ADDENDUM 01

Roseville Joint Union High School District
West Park High School, Phase 2 – Increment 1
DSA Application Number: 02-118062

DLR Group Project No: 75-19101-00

L1.1A

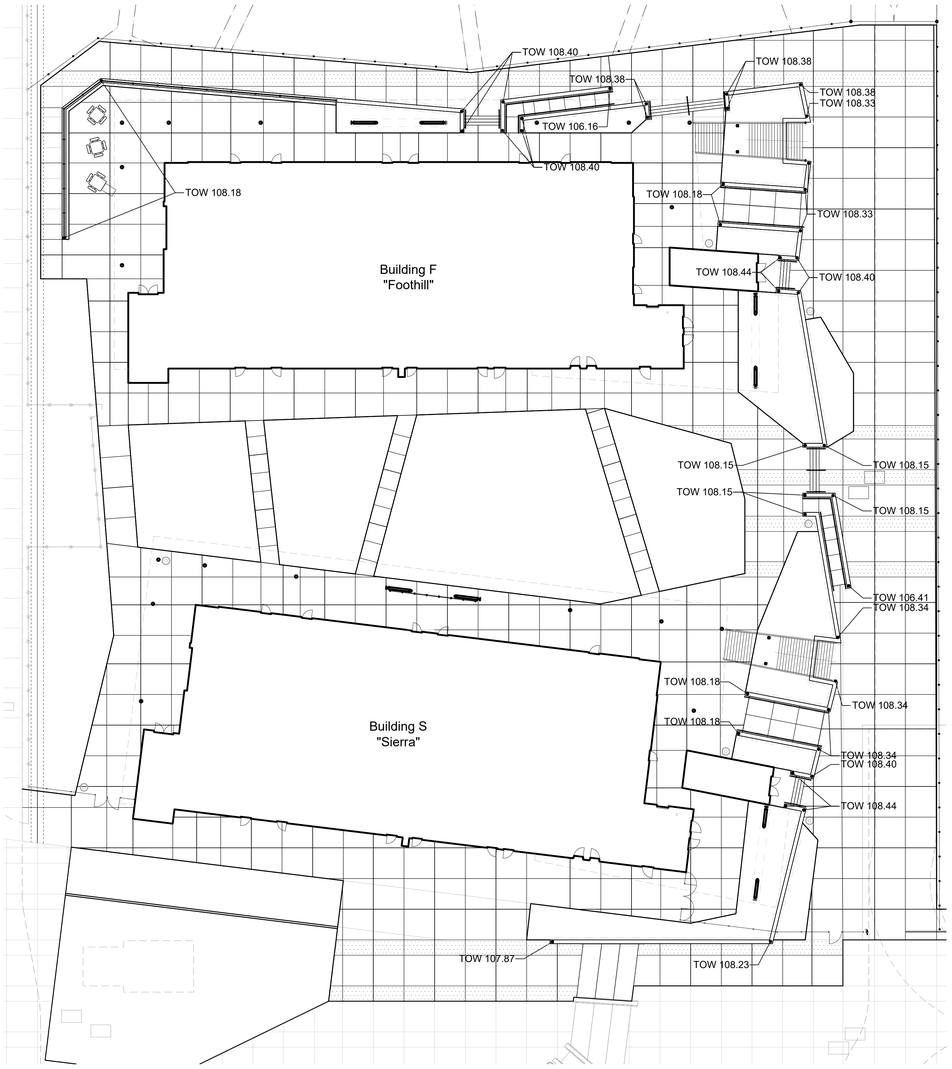
6. **Sheet L1.1A - LAYOUT PLAN**
   - A. *NEW SHEET*
   - B. *Added to show entire length of new post and cable fence along High School Road and entry road to the visitor's parking lot*

A1.F1.1

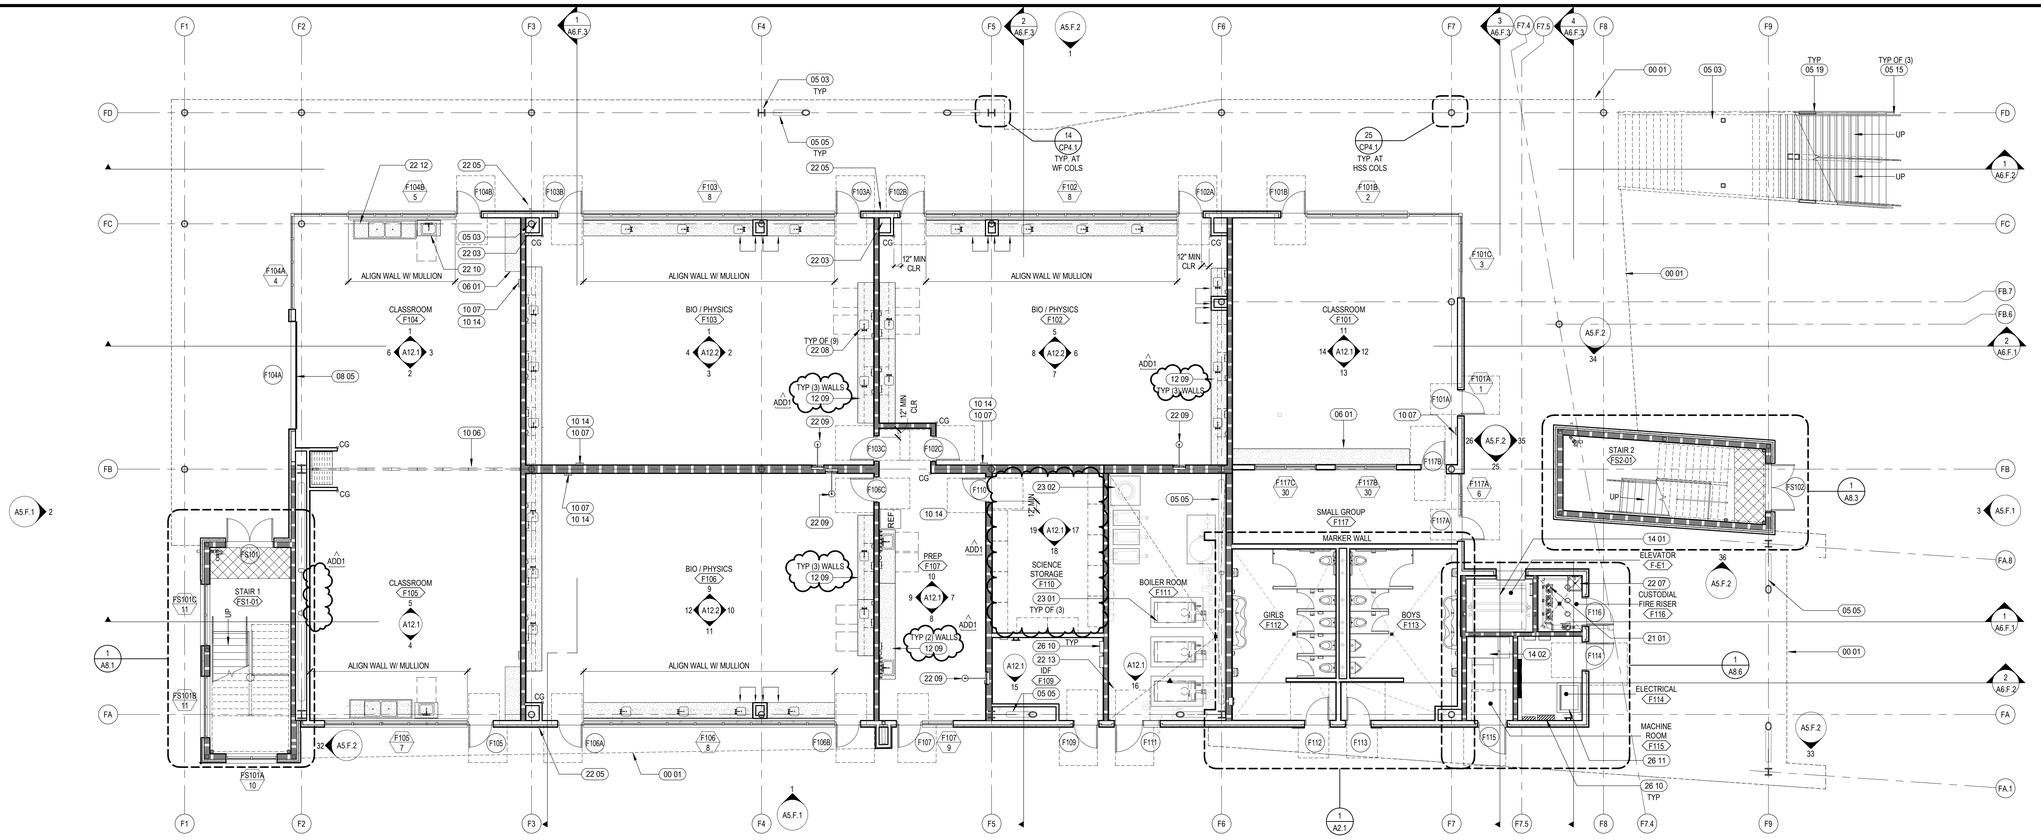
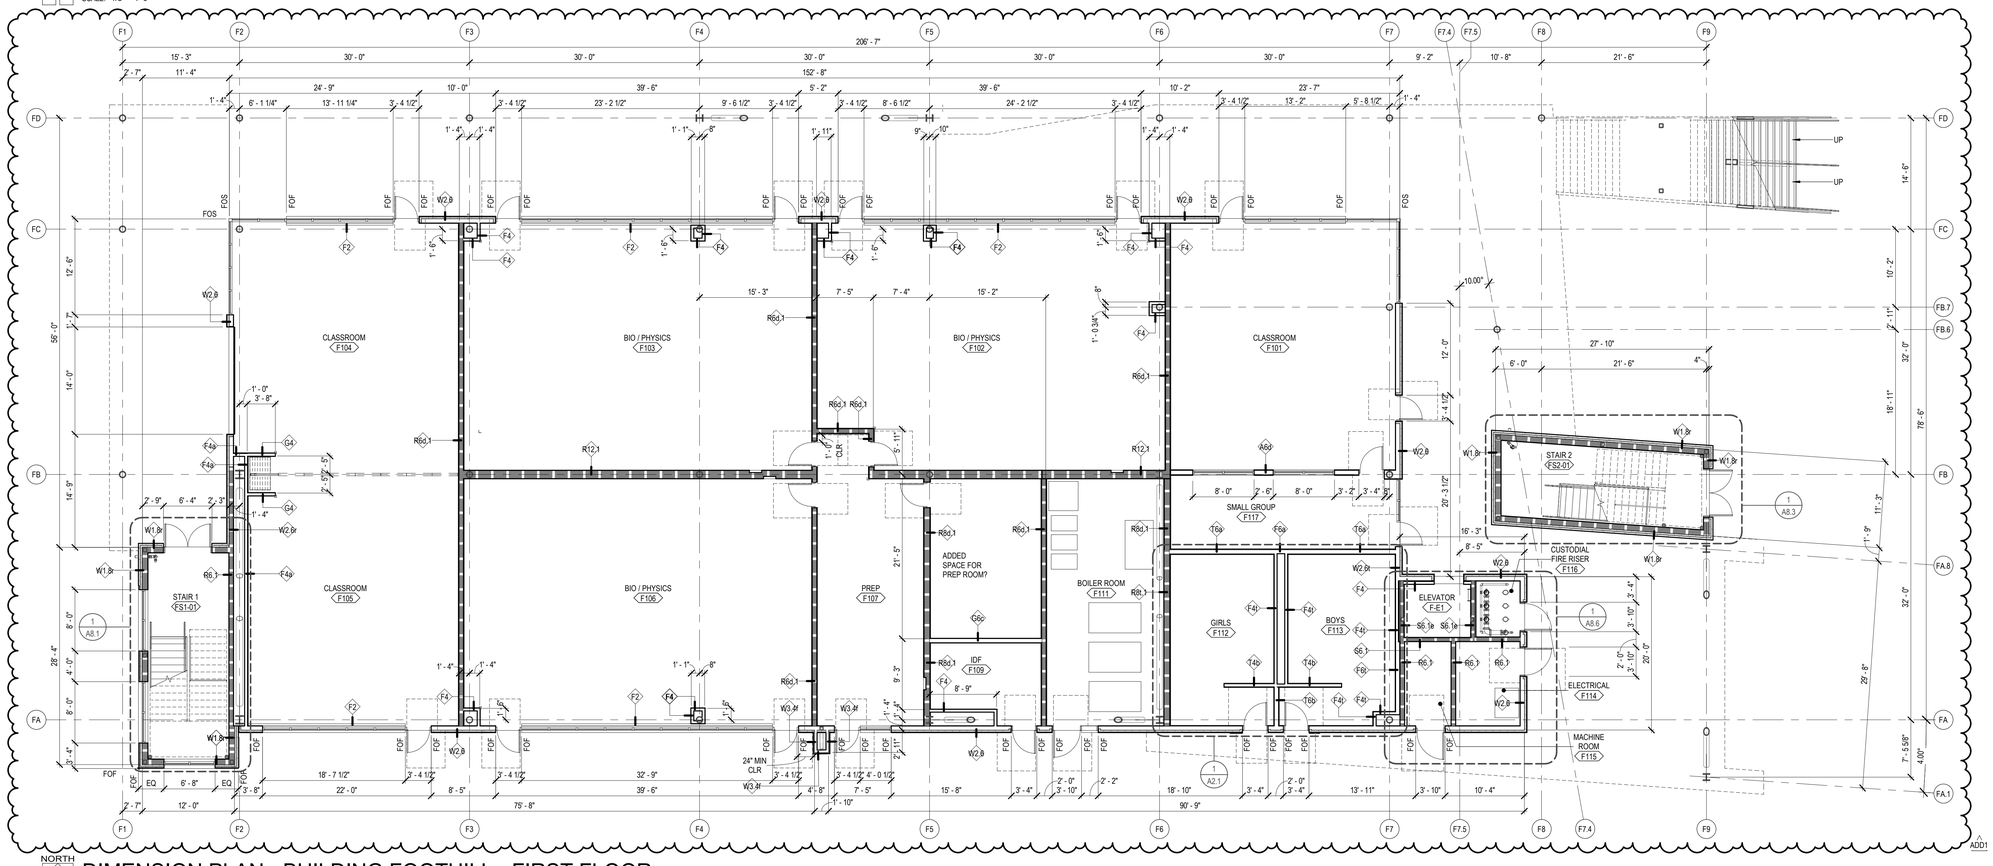
RFI 31 ..... Page A1.F1.1 – Floor & Dim Plans – Bldg F – First Floor. Casework on floor plans, Room F105 but not elevated on sheet 6/A12.1. Please clarify casework and finish.
Answer..... *REMOVED counter graphic from A1.F1.1 Room F105. See attached sheet.*

9. **Sheet A1.F1.1 - FLOOR & DIM PLANS – BLDG F – 1ST FLOOR**
   - A. *Dimension Plan – CLARIFIED various dimensions for constructability*
   - B. *Floor Plan – REMOVED counter graphic from Room F105*
   - C. *Floor Plan – ADDED storage shelving to Room F110*
   - D. *Floor Plan – MODIFIED keynote 06 01 to be 12 09 Laboratory Casework in Rooms F102, F103, F106 & F107*
   - E. *MODIFIED keynote 22 07 to include detail 51/A10.4 reference. Note: This update occurs on multiple sheets not included with this addendum*

A1.F2.1

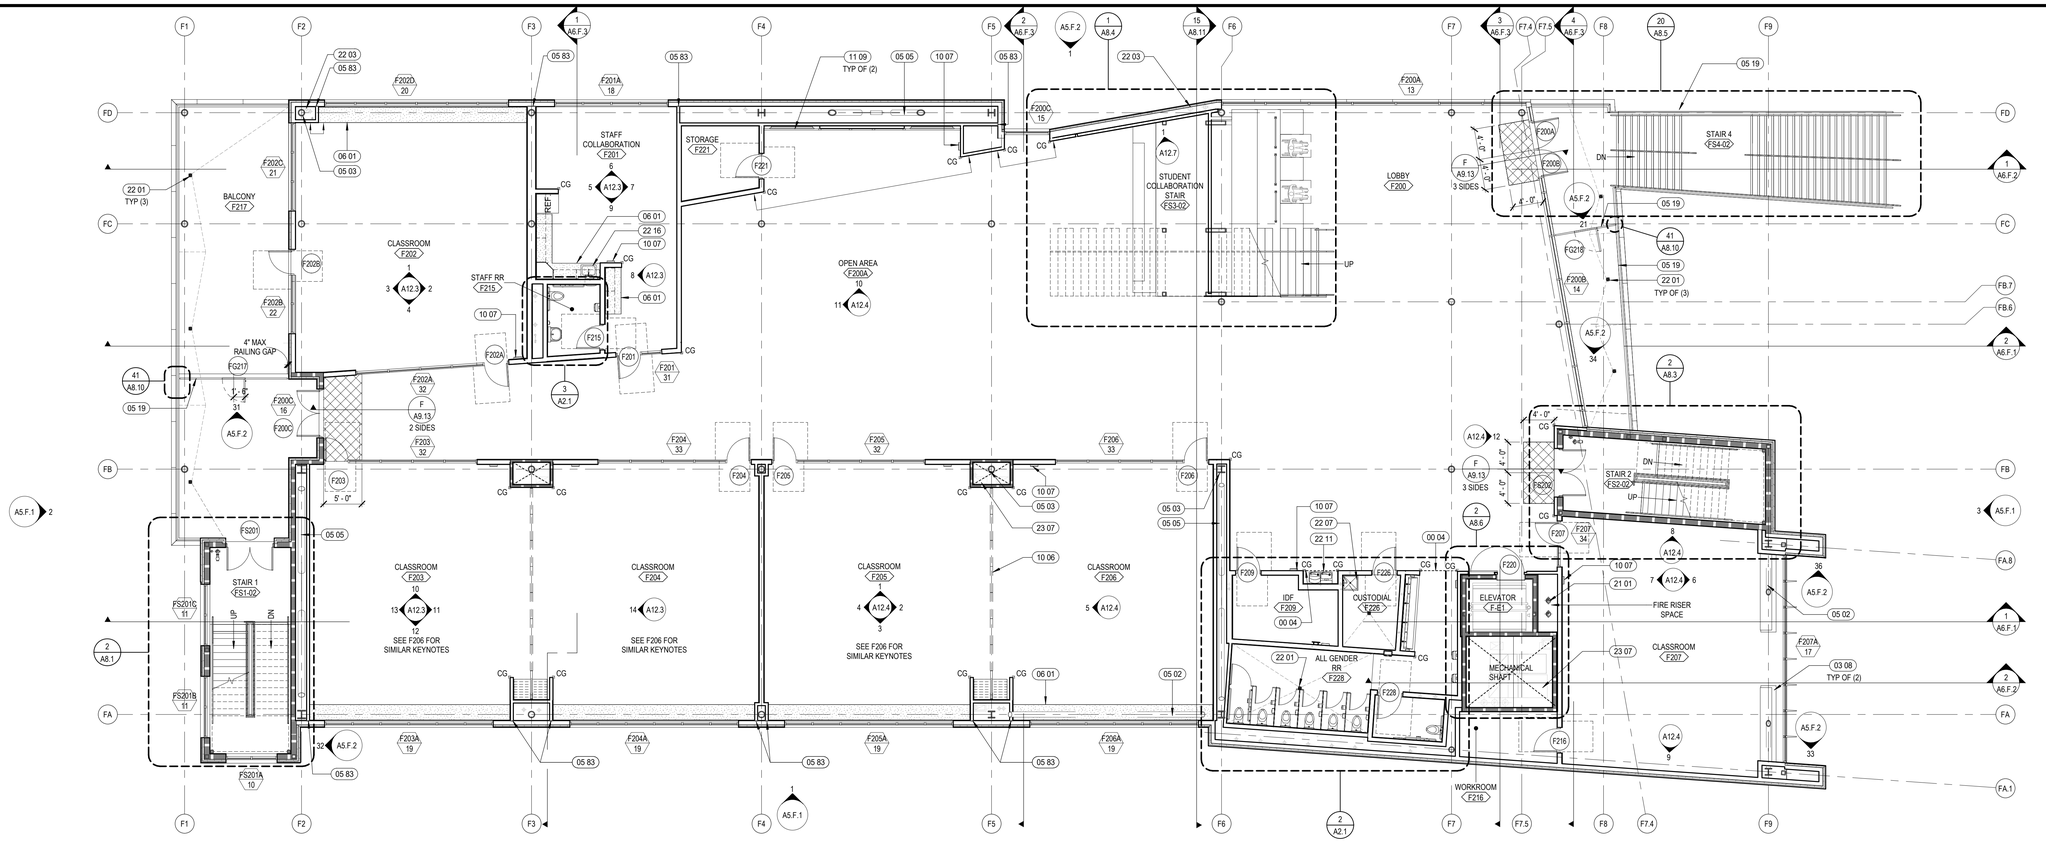
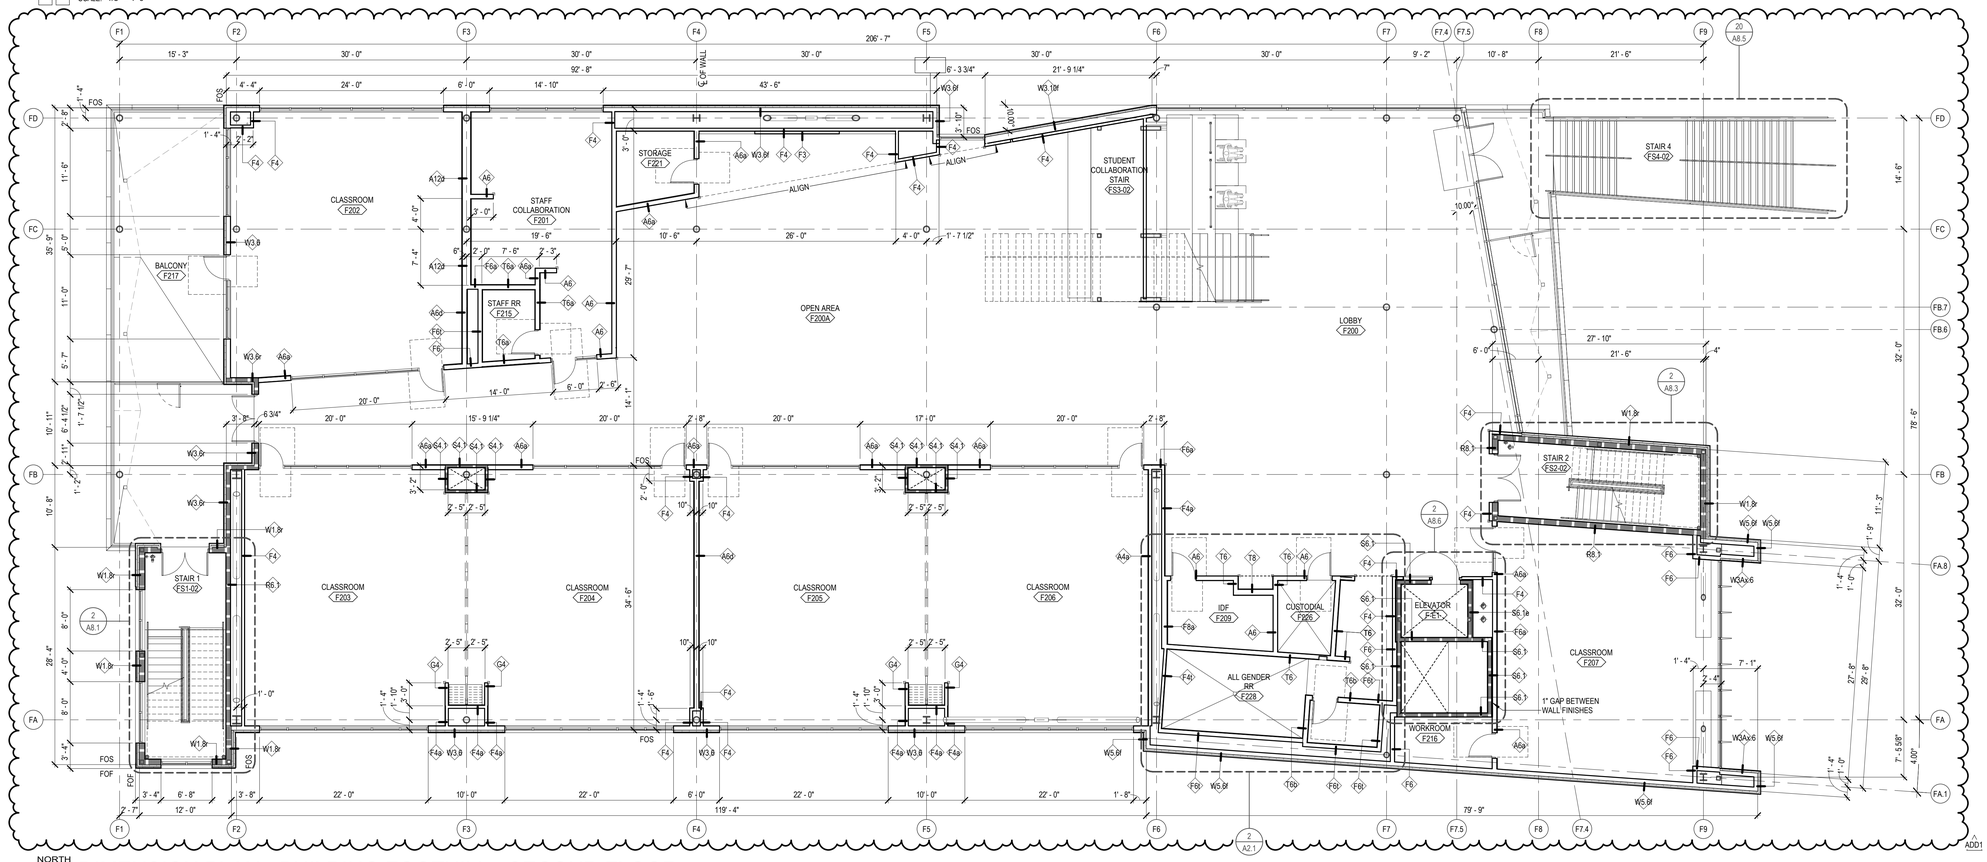
10. **Sheet A1.F2.1 - FLOOR & DIM PLANS – BLDG F – 2ND FLOOR**
    - A. *Dimension Plan – CLARIFIED various dimensions for constructability*
    - B. *MODIFIED keynote 22 07 to include detail 51/A10.4 reference*

A1.F3.1

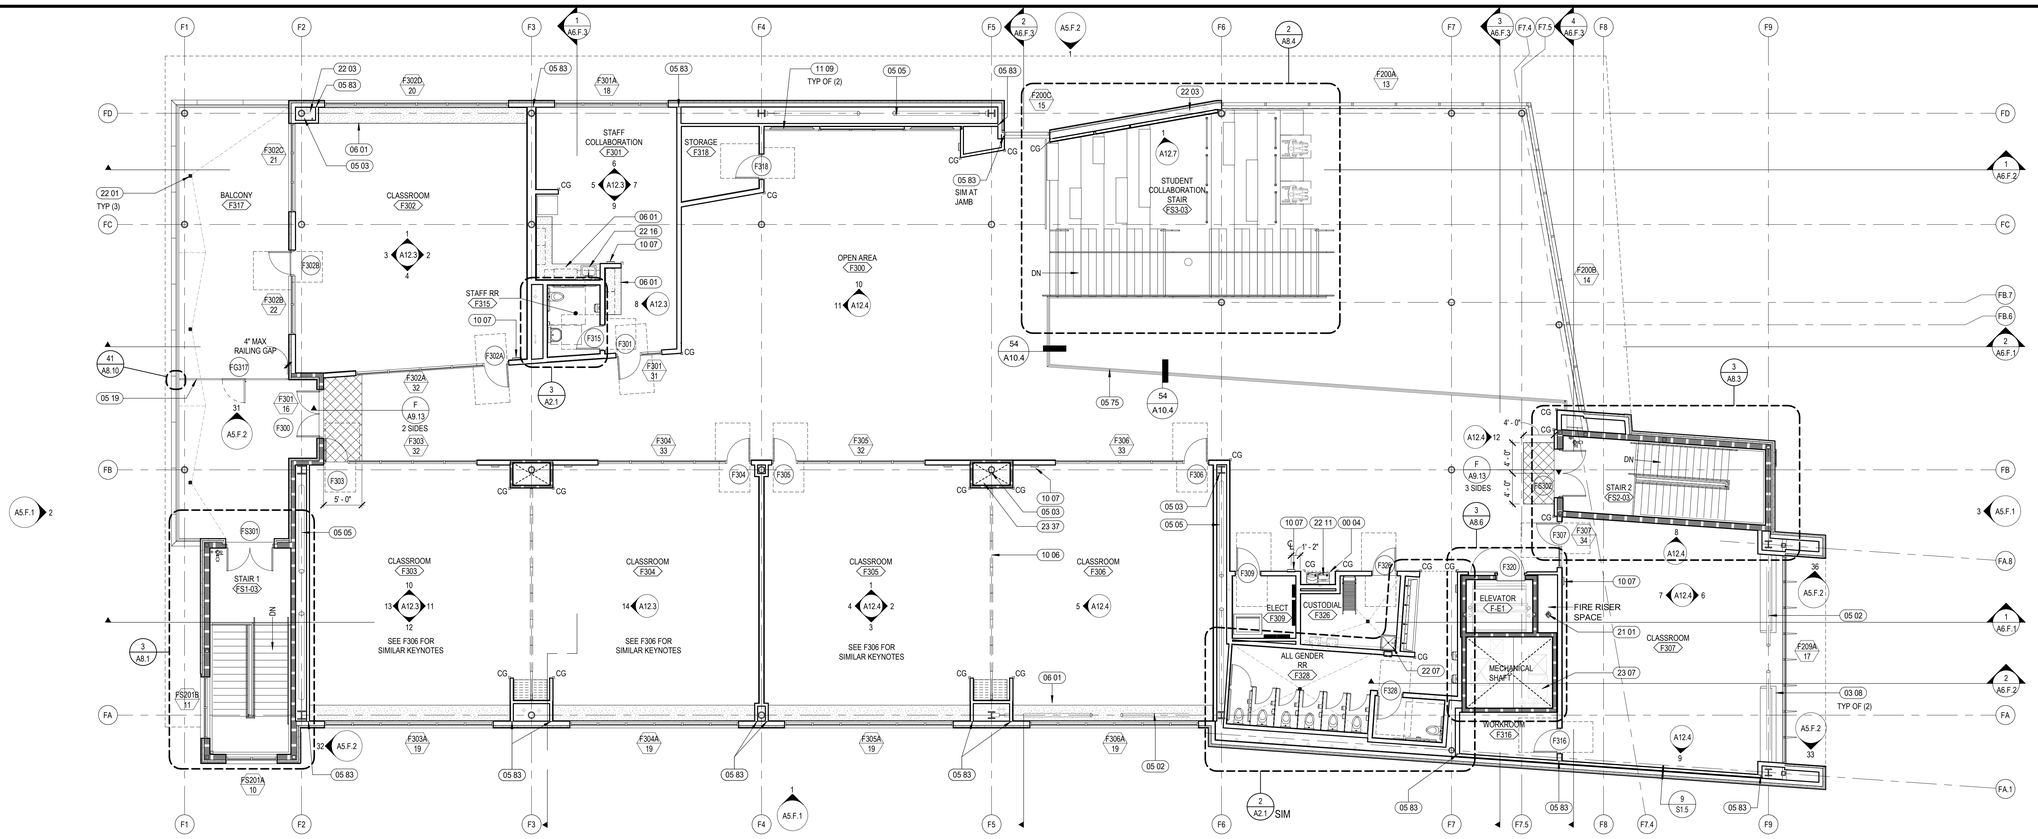
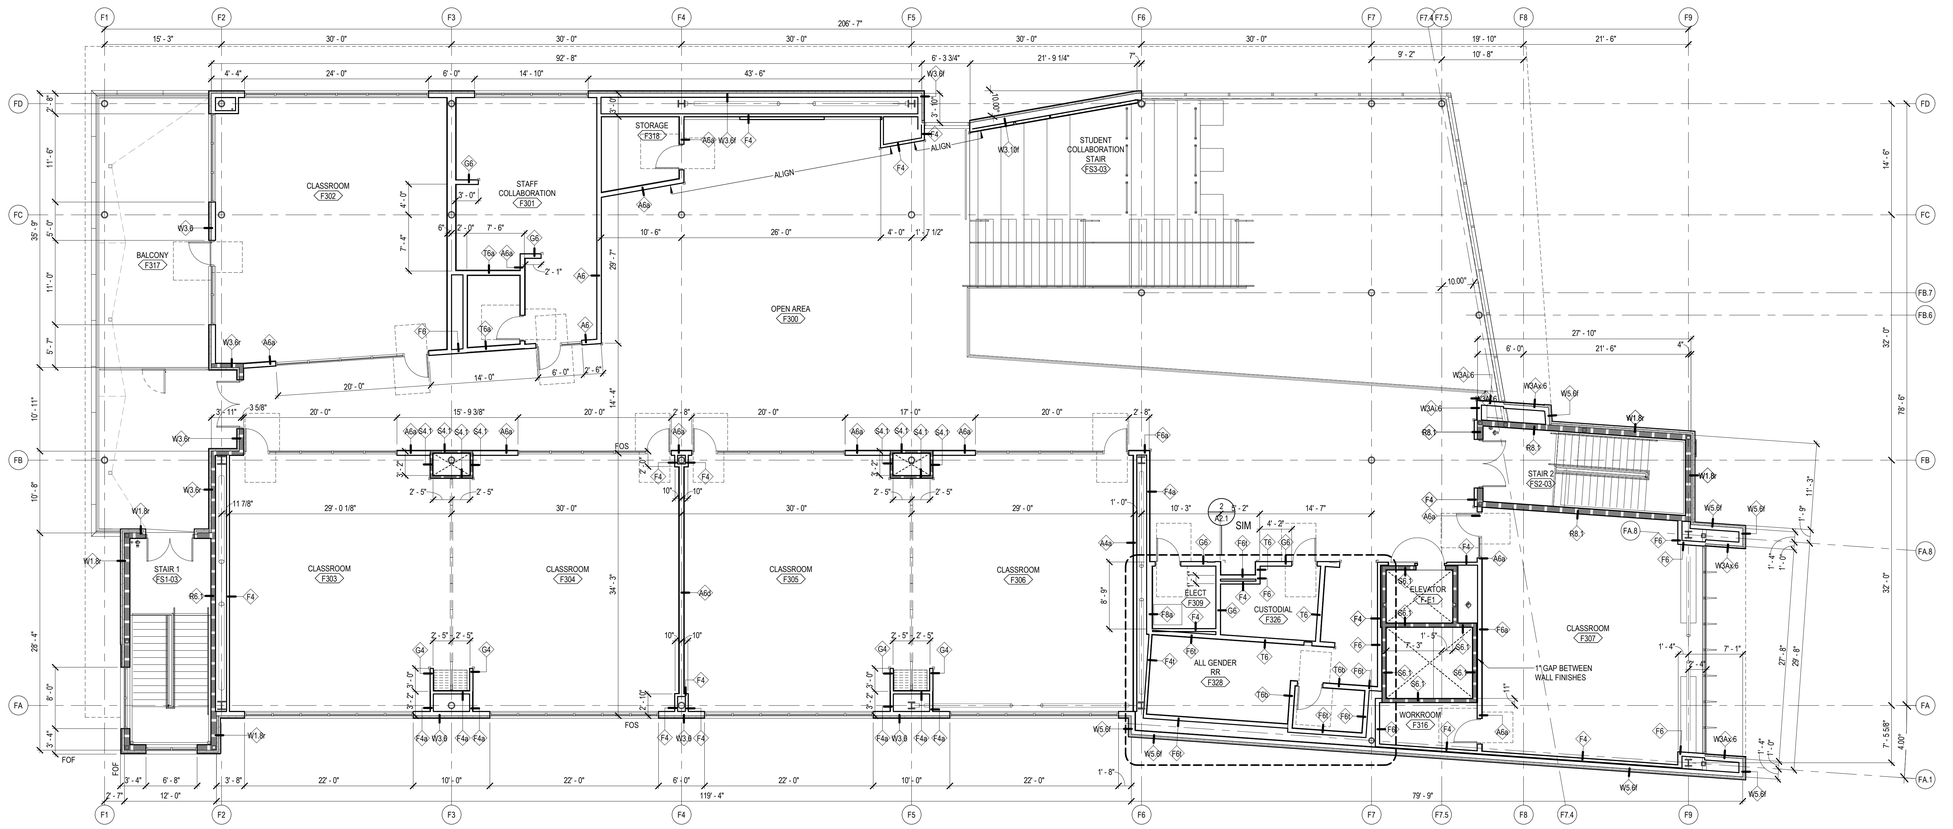
11. **Sheet A1.F3.1 - FLOOR & DIM PLANS – BLDG F – 3rd FLOOR**
    - A. *MODIFIED keynote 22 07 to include detail 51/A10.4 reference*
